Index 700-120 Enhanced Highway Signing Assemblies

COMMENTARY

COMMENTS AND RESPONSES

SHEET
12 of 15

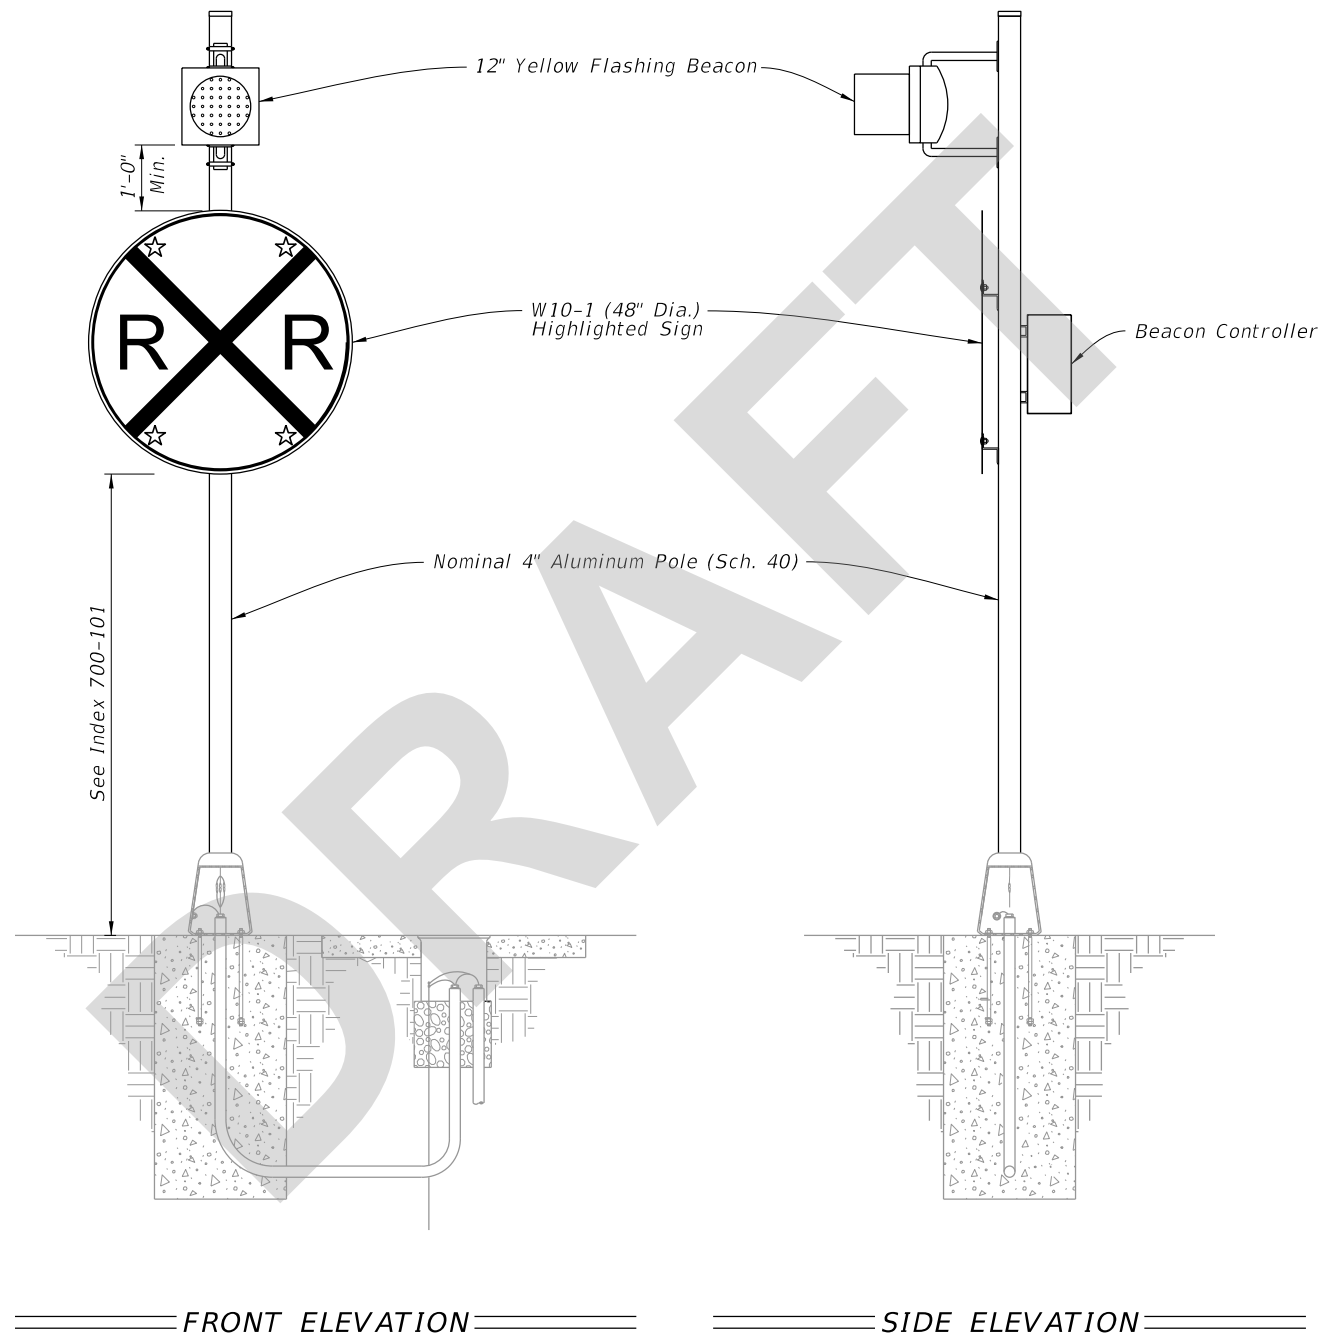
COMMENT: Note 2b has awkward wording. Suggest something like... 1/2" expansion preformed joint filler required between sidewalk and spread footing, or just call out in plan view instead of in a note. Also in Note 4, does a 6'-6" footing require an additional bar? Not sure the covers that.

RESPONSE: Agree. We will adjust Note 2b to what is suggested and add a callout. We will also update Note 4 for clarity.

INDEX 700-120	SHEET 14 of 15
------------------	-------------------

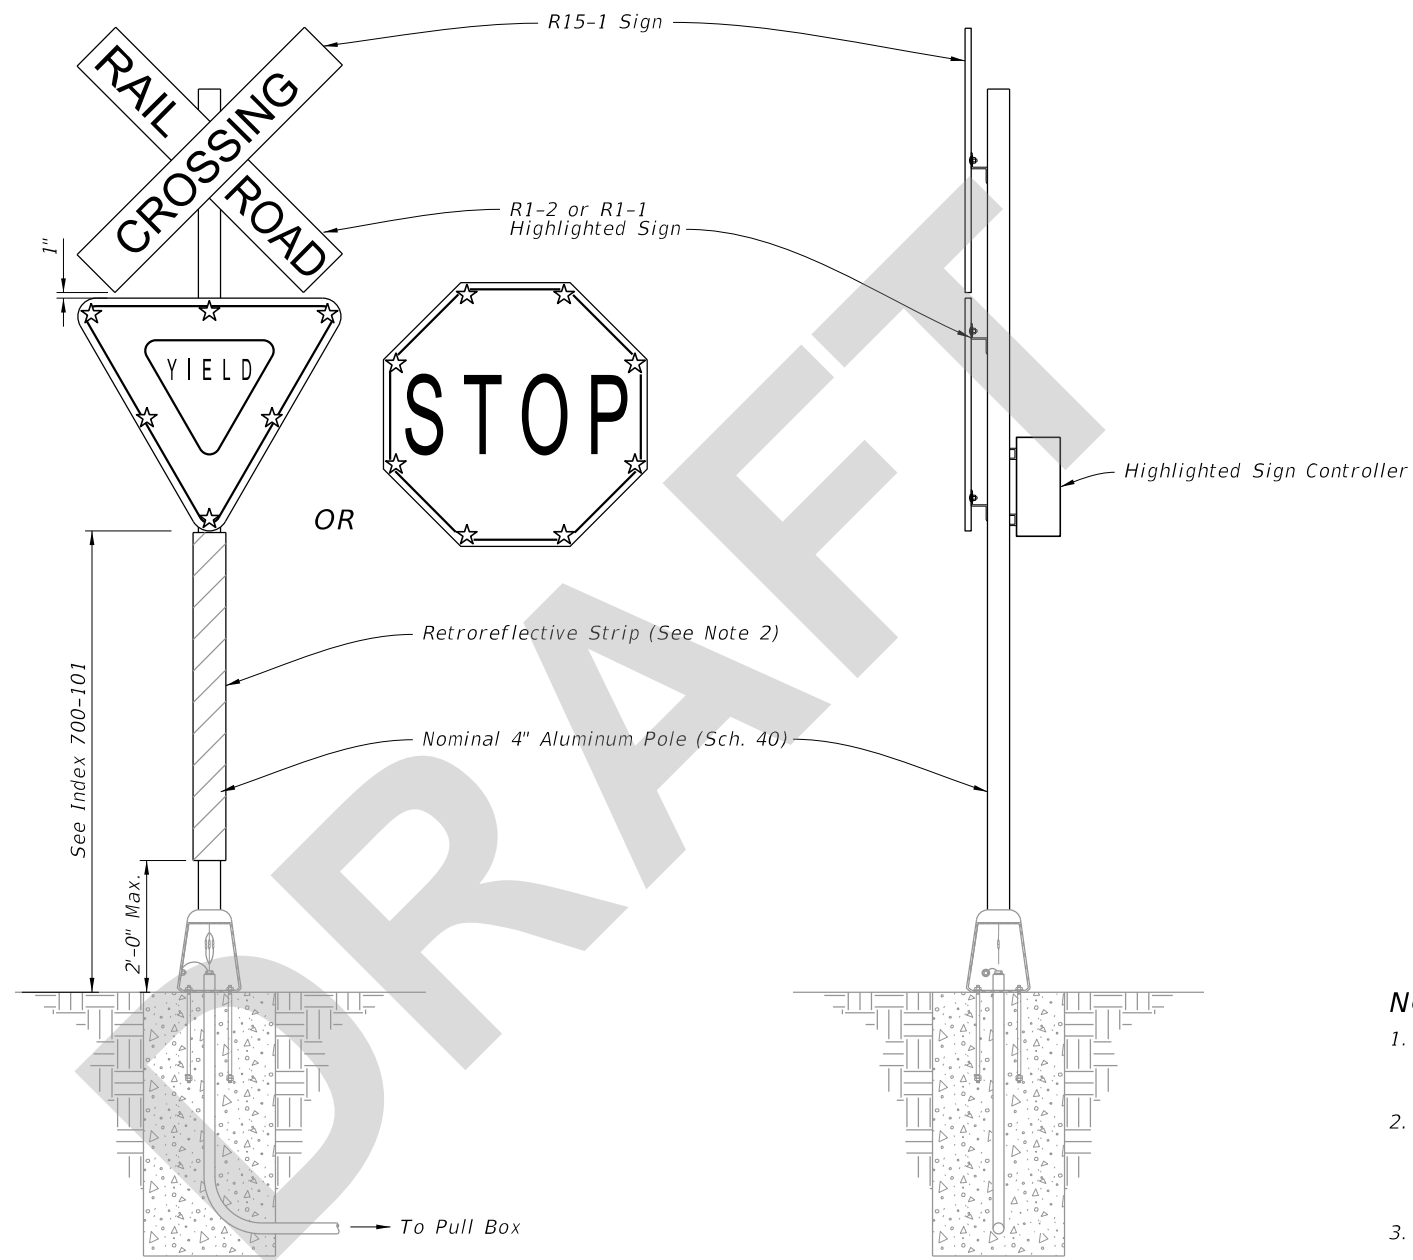
(new RR Crossbuck): MUTCD figure has red strip on front, white strip on back of POST, AND 8B03 (07) A strip of retroreflective white material not less than 2 inches in width shall be used on the back of each blade of each Crossbuck sign for the length of each blade, at all grade crossings where Crossbuck signs have been installed, except those where Crossbuck signs have been installed back-to-back.

Section 700 does not appear to address the WHITE strip on the back of the support, only the back of the crossbuck blades. Please verify.

RESPONSE: Agreed. We will update the draft to "Transformer Base." Also agree regarding the white strip on the back of the post. We will adjust the note in the index to make it clear that the back strip must be white.
